APPLICATION DA-2001/682/B

NOTICE OF DETERMINATION OF APPLICATION TO MODIFY DEVELOPMENT CONSENT Issued under Section 96 of the Environmental Planning and Assessment Act 1979

Description	Stage 1 - Construction Of Northern Grandstand And Ancillary Function Rooms. Stage 2 - Construction Of Northeastern Wrap-Around Grandstand (On Part Of Lot 94 Andrew Lysaght Park) Modification B - modification to conditions 12, 32, 33, 63 and 64 and additional car parking
Location	Lot 143 DP 786508, Lot 101 DP 872951 WIN Entertainment Centre, 9-11 Crown Street, WOLLONGONG NSW 2500

REF. PLAN A35
DESIGN LAYOUT
SK.01
SECTION

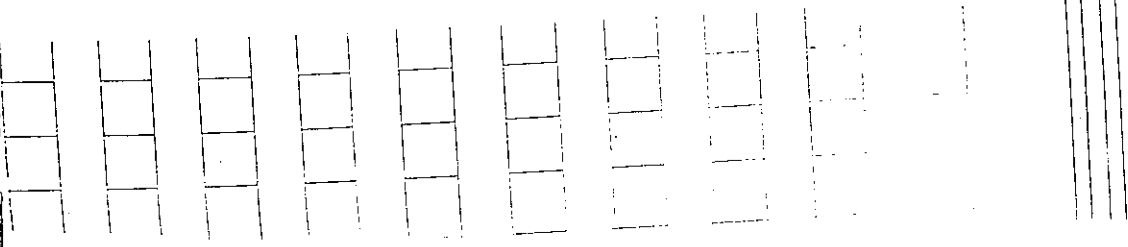
Fixed seating within the auditorium accommodates 4496 people. The original design incorporated hand-rails as designed on Sketch 01. (Refer to extract of plan A35). Shop drawings prepared by Siebel also showed the provision of guardrails to a height of 500mm above the stepped platform. (Refer Sketch 02).

SCALE 1:50
 DRAWING No. P2ALT
 REVISION 0

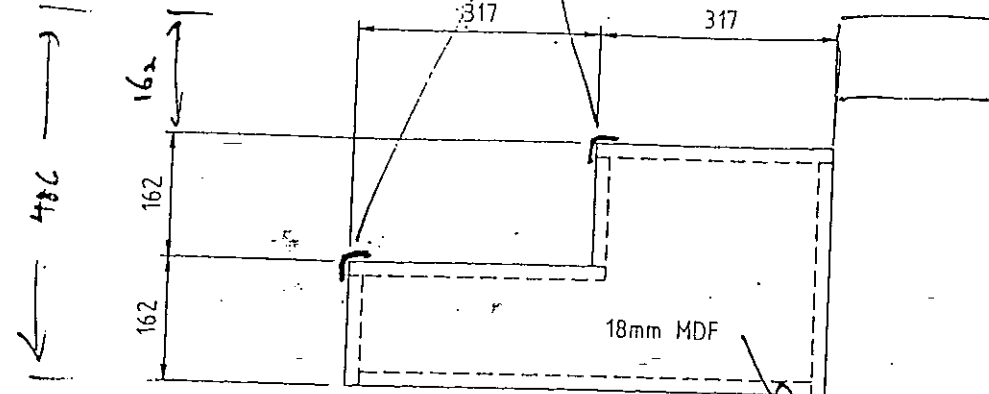
WIDER THAN PREVIOUSLY SPECIFIED
 ~1200mm

DIF 9.55 - 6.15
 = 3.40
 OK

CONSISTENT RISERS, OK

EXTRUDED ALUMINIUM STAIR NOSING PREVIOUSLY SPECIFIED

19mm A BOARD PLYWOOD PREVIOUSLY SPECIFIED

SCALE 1:50 DRAWING No. P3ALT REVISION 0

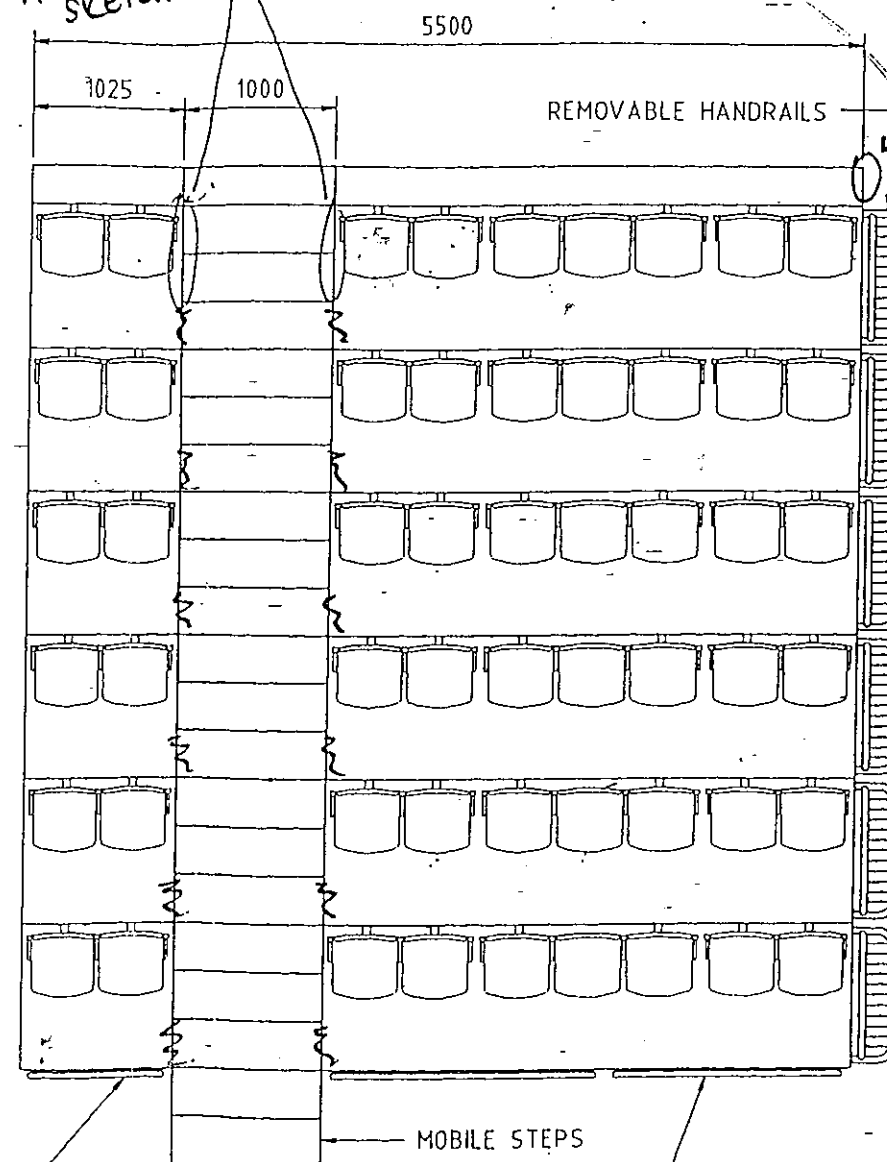
PERMANENT
BALUSTRADE
REQ'D

PREVIOUSLY
PERFORATED
STEEL INFILL
